RE: Eddyline Ranch subdivision Planning and Zoning preliminary plat hearing

Please see below the applicant's response in red to the recommended CONDITIONS OF APPROVAL from the Planning and Zoning Commission provided at the March 11, 2025 hearing:

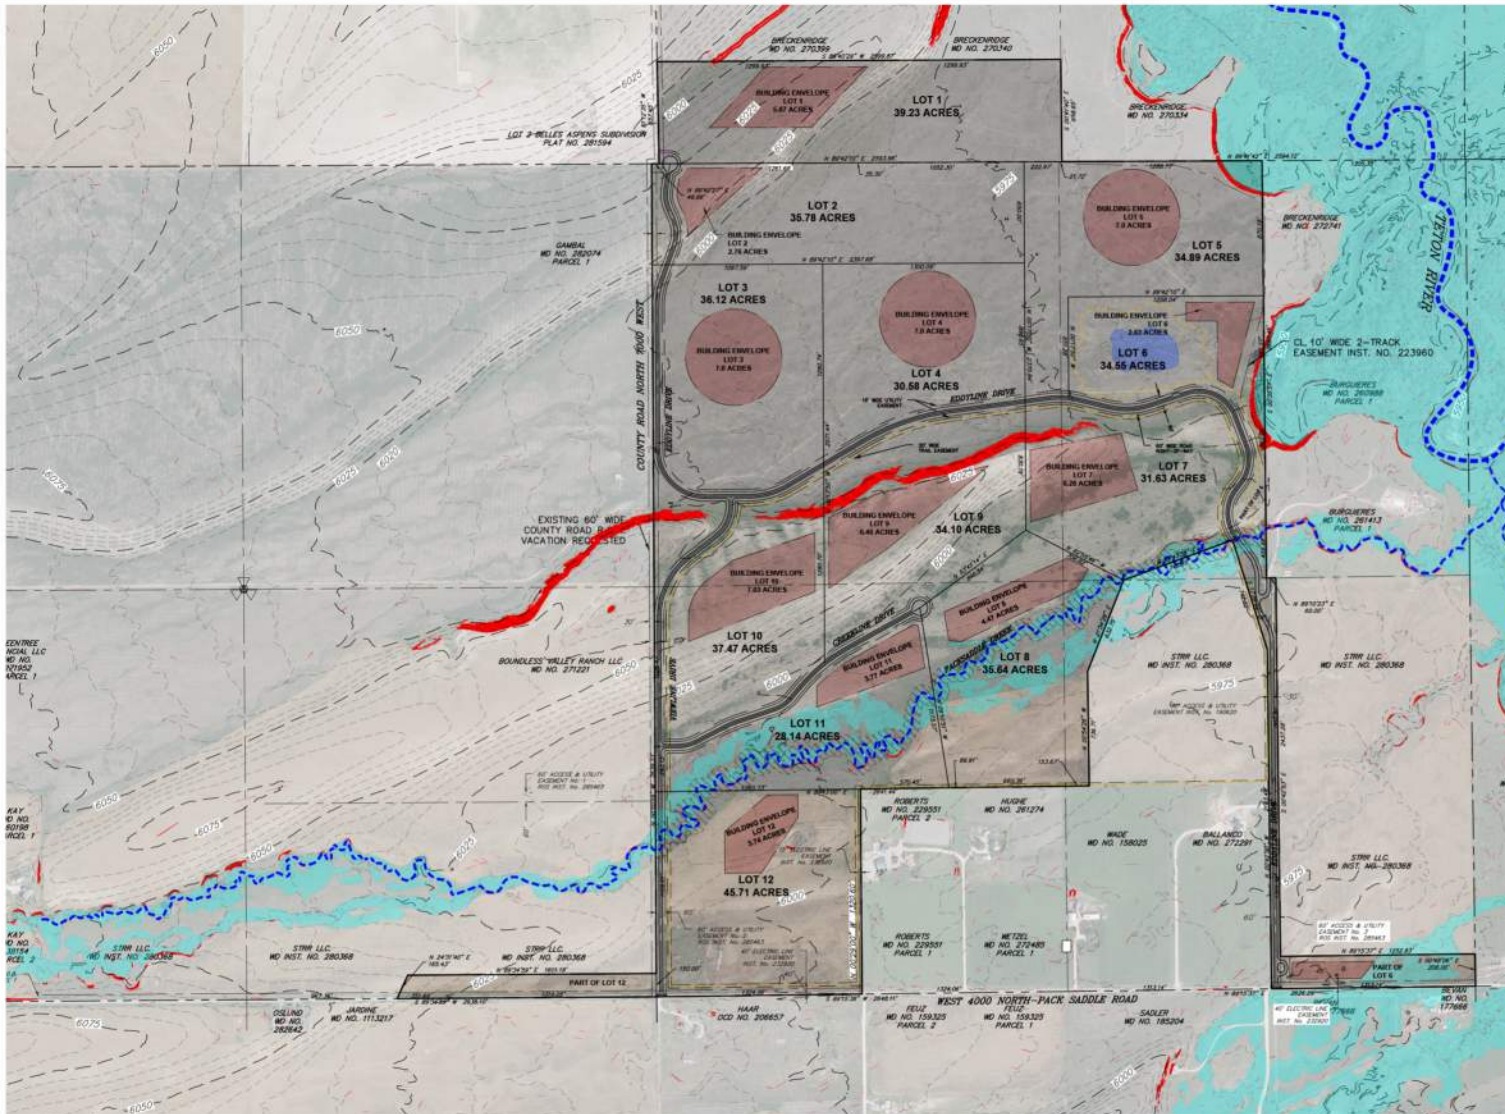
d. Interior road design incorporates a significant amount of fill. Public Works will be referencing the Improvement Plans for inspection of infrastructure. Improvements will need to be constructed per the Improvement Plans and meet County road standards in order to receive final approval.

The applicant has revised the Improvement plans to reduce the amount of fill in areas where road grade had previously exceeded 2 feet above existing grade. Two feet above existing grade provides for adequate road drainage with a road crown of 4% per Teton County road standards.

Priority Habitat and Species Mapping

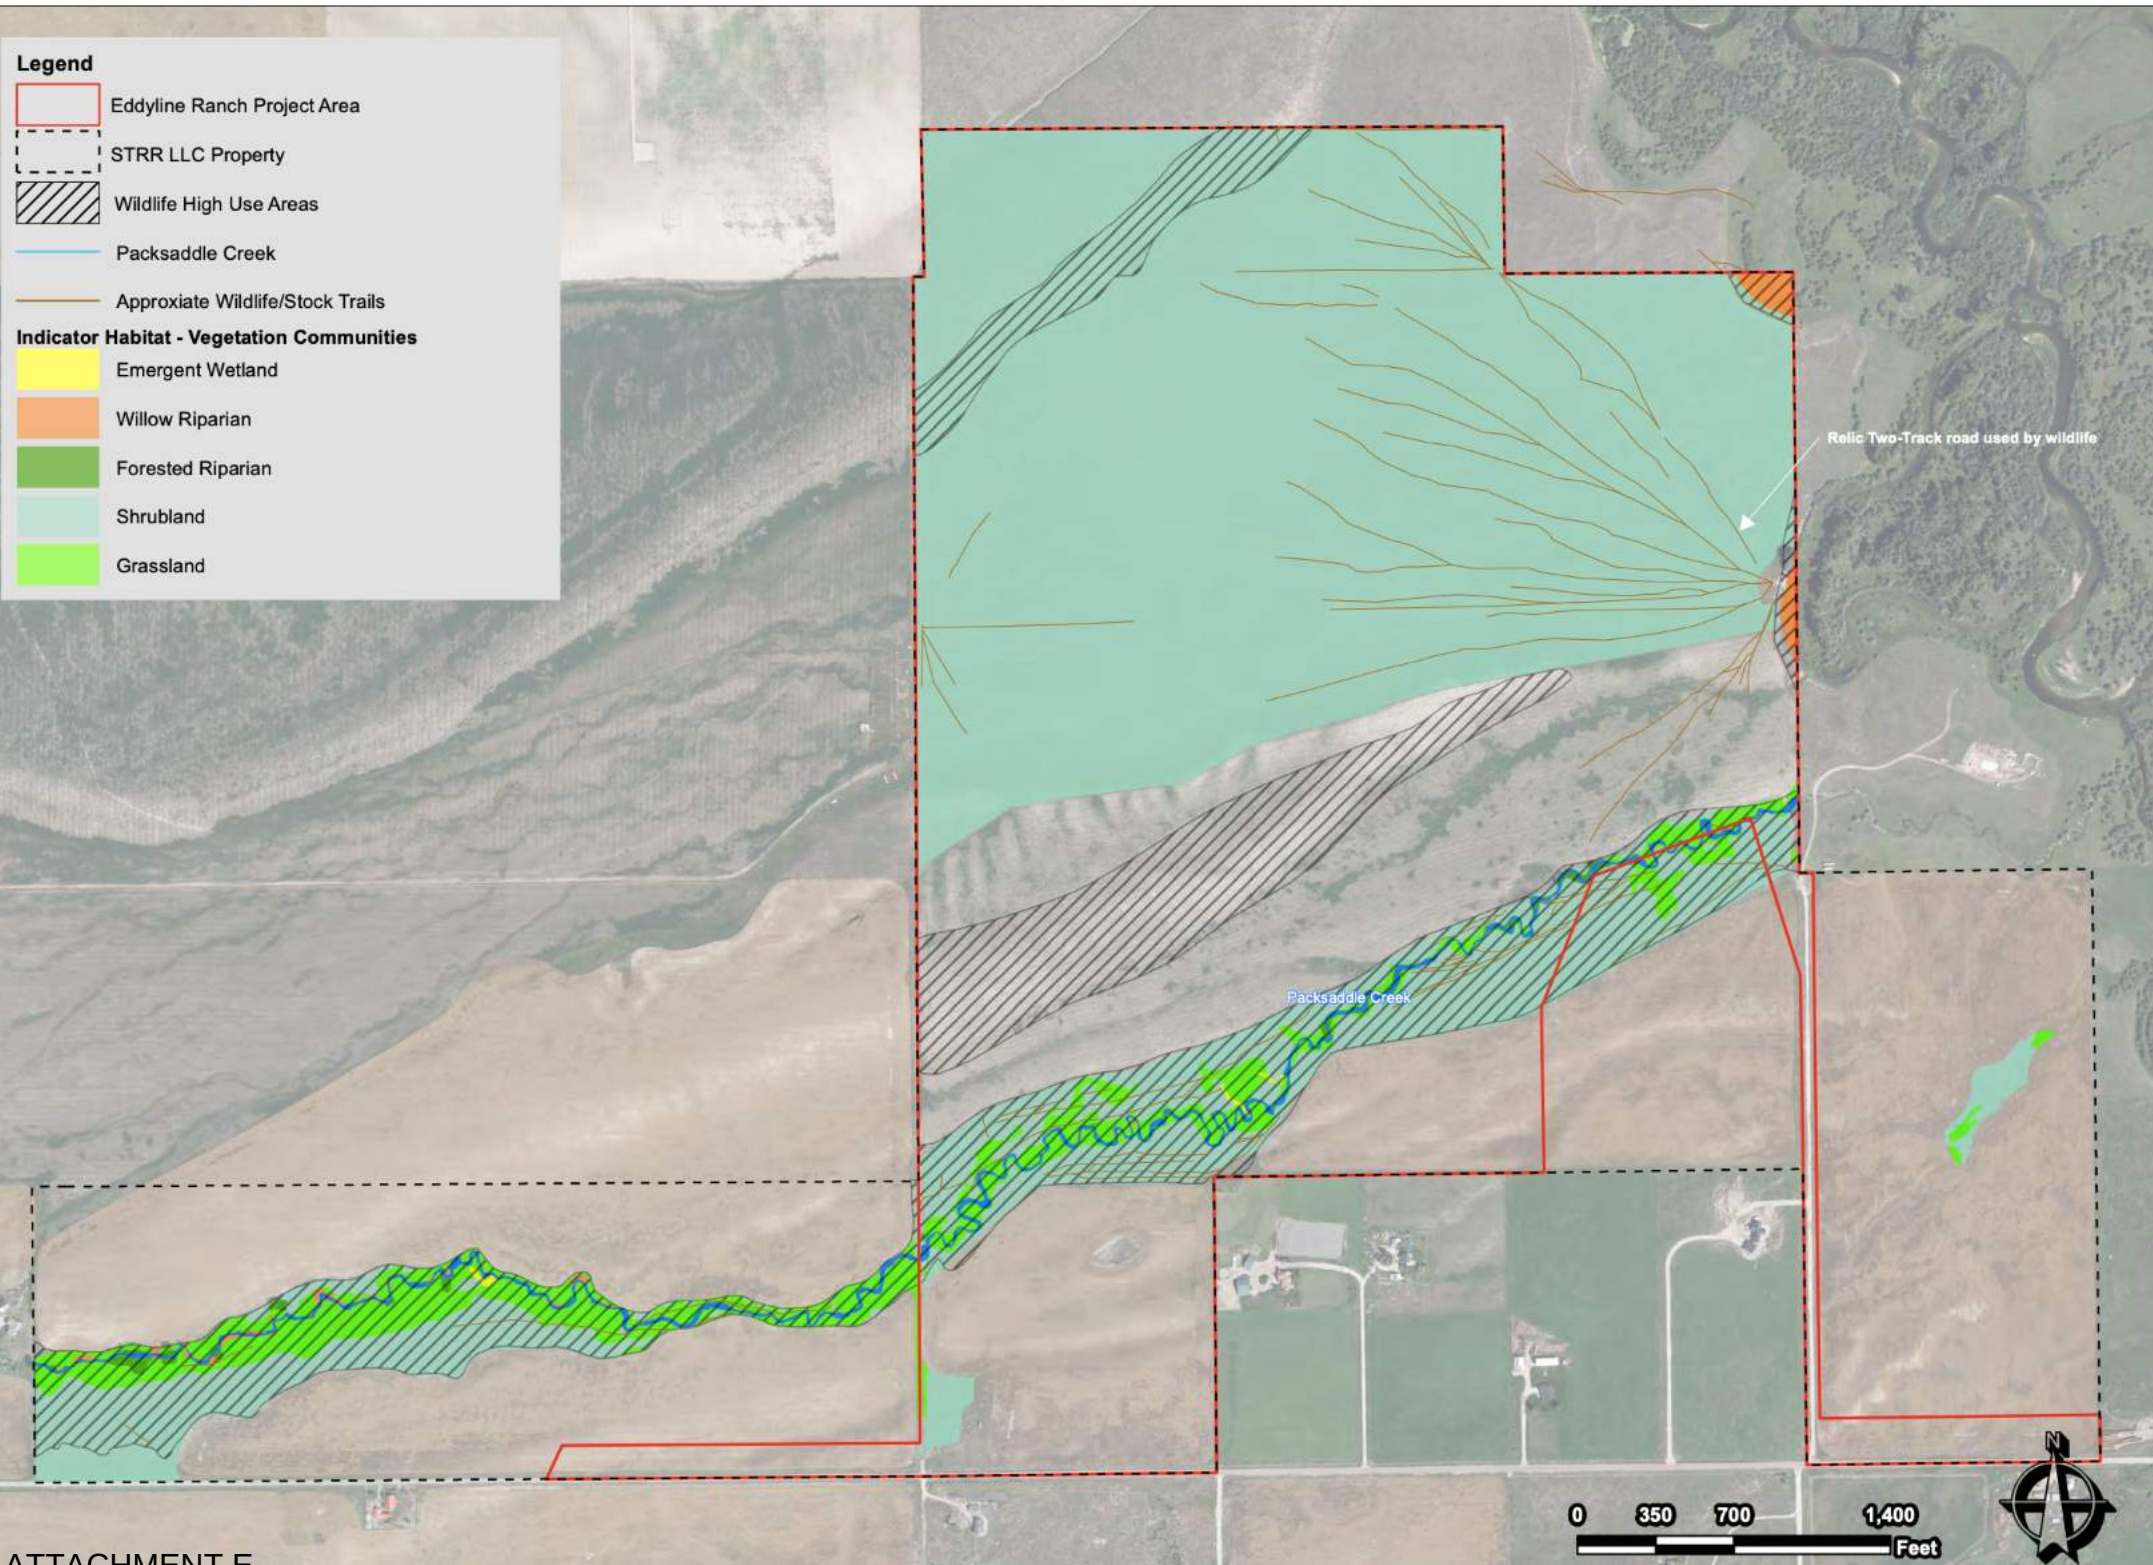
9. Address building envelopes #1 and #2 as they appear to be in the wildlife migration corridor.

Building envelopes #1 and #2 were located upslope of the wildlife migration corridors. Attachment E shows the location of migration corridors as mapped in the WHA prepared by Biota which traverse along the toe of the slope on those lots.
